# Application for resource consent or fast-track resource consent

## 1. Pre-Lodgement Meeting

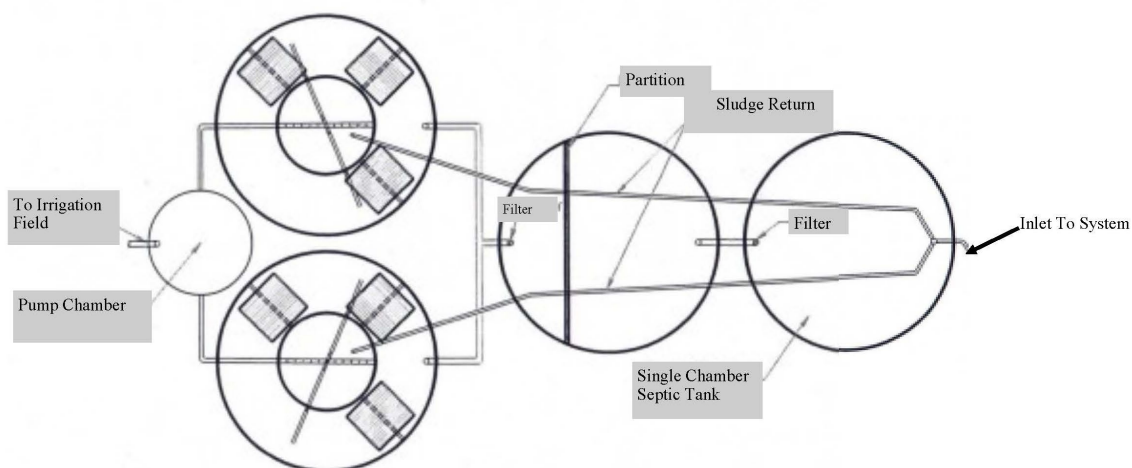
Process Description of System	Aerated submerged fixed film media Fine bubble aeration
Volumes <ul style="list-style-type: none"> <li>Total Operational Volume</li> <li>Number of tanks</li> <li>Total Liquid Volume</li> <li>Emergency Storage</li> </ul>	4000L/Day 5 (4 x ReIn 3200L septic tanks and one TechTreat Pump Chamber 1200L) 12840L 3200L
2 Filters (AS/NZS 154 Standard) Primary septic tanks	Simtech STF 110 septic tank bristle filter
Aeration 2 Blowers Treatment Tanks <ul style="list-style-type: none"> <li>Make/Model</li> <li>Run Time</li> <li>kW</li> <li>Power Usage</li> </ul>	Nitto LA80 18hrs/Day 0.086kW 86x18=1.548 kWh/day x2 = 3.096kWh/day
Recirculation	Sludge return from clarification to septic
Submersible Pump (Pump chamber) Trevoli EF30/Davey Sump Pump or similar <ul style="list-style-type: none"> <li>kW</li> <li>Flow Rate</li> <li>Run Time (based on max 4000L/Day)</li> <li>Power Usage (based on max 4000L/Day)</li> </ul>	1.1kW 160L/minute 25mins/day 0.458kWh/day
